Parklands Rehabilitation

Approval of Preliminary Site Development Plans

United States Department of the Interior

NCPC File Number: 8415

Parkland Rehabilitation Existing Paths

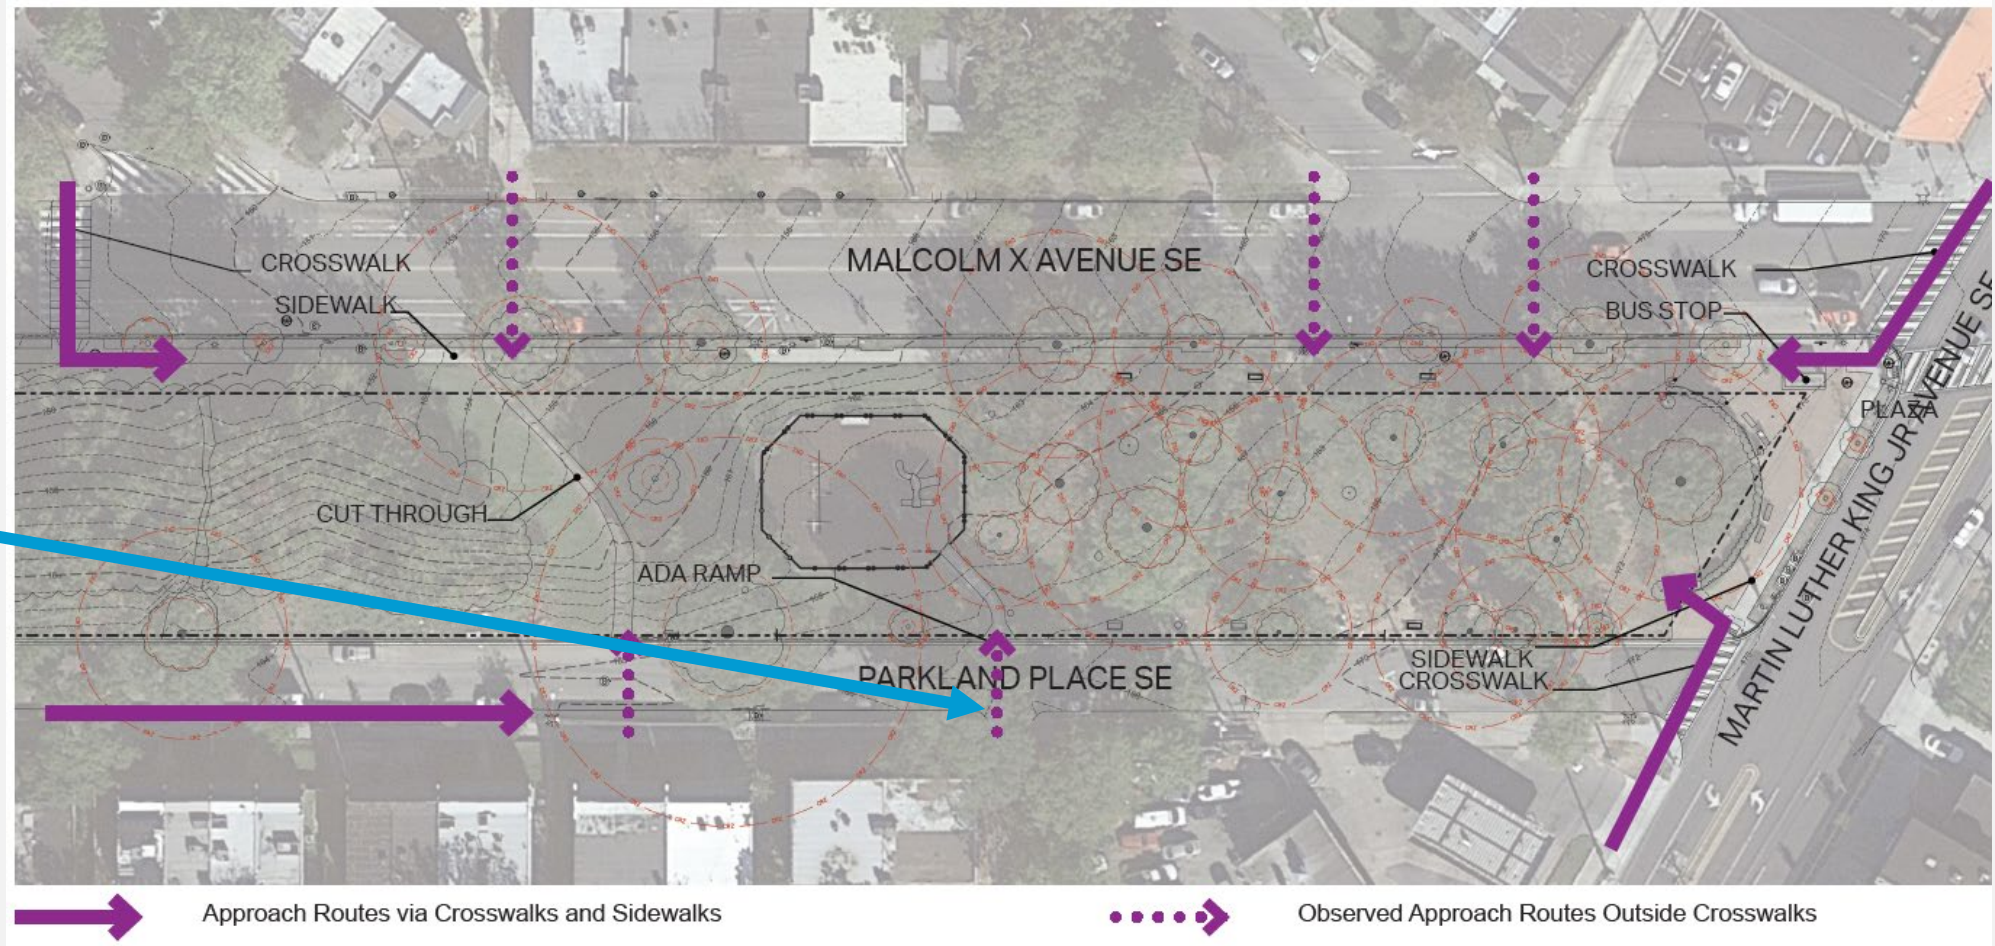
Applicant requested a new midblock crosswalk from DDOT to accommodate existing known routes. DDOT has thus far not approved the request.
